PLANNING REPORT

Architectural Review Board

Laird Residence Revisions 25-083MPR

Building Massing and Scale

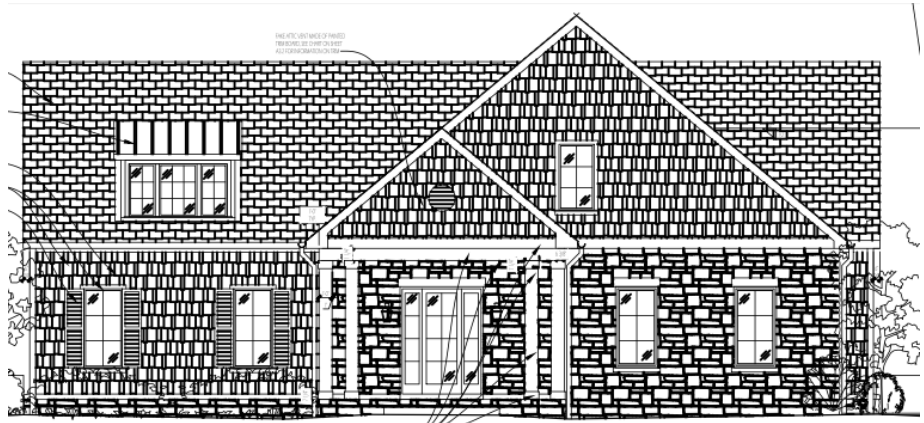
The massing and scale is much as approved in May. Differences will be noted with discussion of each elevation.

East Elevation

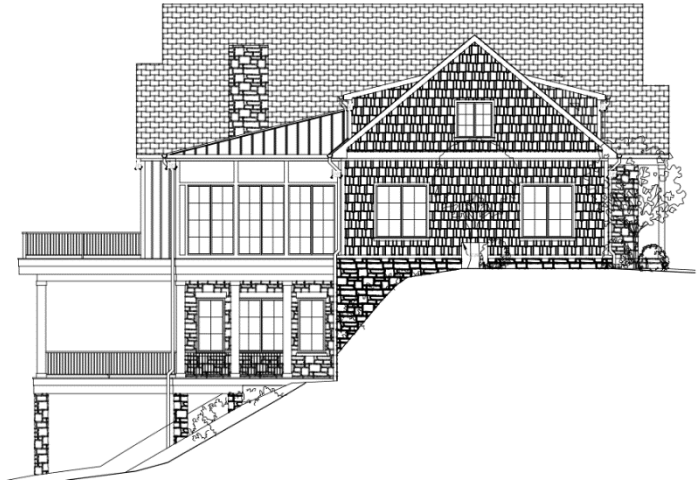
The rear elevation is unchanged; elevation provided for reference.

South Elevation

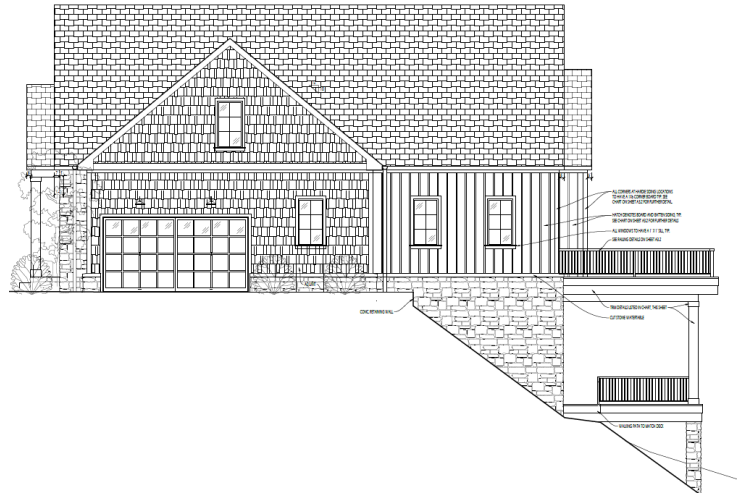
The south elevation now shows the side-entry garage. The garage gable is brought forward slightly, and materials are slightly modified: what was previously all stone now has a stone water table and shake shingles. The garage door has narrowed from 18' wide to 16', and light fixtures are added above the door. A single window to the right of the garage door balances this gable. The rest of the previously-approved fenestration remains.

A more at-grade access is shown from the lower deck to the garden area. This accommodates the grades at the house's new location on the lot. All other details remain the same; staff has no concerns.
